5 August 2026

Arrowsouth Properties Limited
C/- Scott Freeman
Southern Planning Group
PO Box 1081, Queenstown
9300

PRIVATE PLAN CHANGE REQUEST TO THE PROPOSED DISTRICT PLAN
THE ARROWTOWN SOUTH SPECIAL ZONE
REQUEST FOR ADDITIONAL INFORMATION

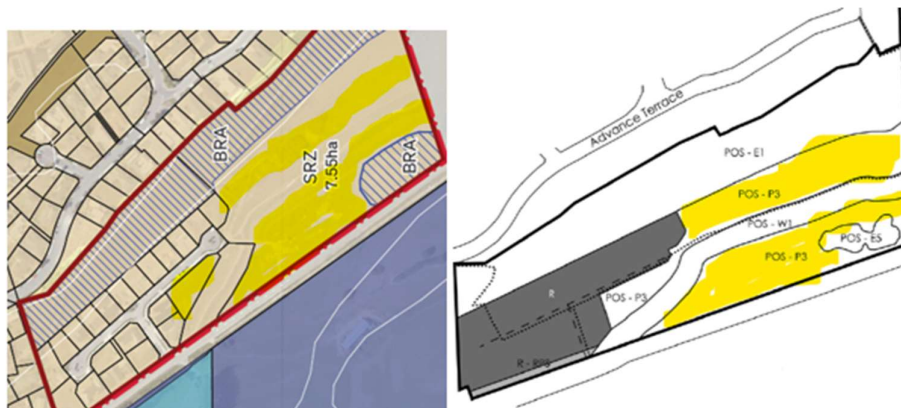
The s32 does not explain why residential development is appropriate in all of the POS-P3 pastoral private open space areas. Landscape evidence to provide an understanding of the effects of the proposal is considered necessary. In particular, information is requested in relation to why the restrictions in the ODP are no longer valid and why the PPC proposal is more appropriate than the status quo. See figures below, the yellow highlights the indicative area in POS-P3 outside the BRA:

3. In consideration of the above comments and reasoning, please provide the below information:
 - a. An assessment of whether it is appropriate to carry over into the PDP the existing ODP rules with regard to POS-P3 under the ASSZ, including any expert evidence demonstrating that they are no longer valid and that the change proposed is more appropriate than the status quo.
 - b. If the continuation of the existing or new OOSM and POSMP is not being proposed, consider the inclusion of proposed bespoke provisions that will suitably manage landscape and ecological effects on-site, supported by expert advice to support these new provisions.
 - c. Update the proposed bespoke provisions within Chapter 27 to ensure that the site will provide a designed urban edge with a landscaped gateway in accordance with 4.2.2.19(c) from PDP Chapter 4.
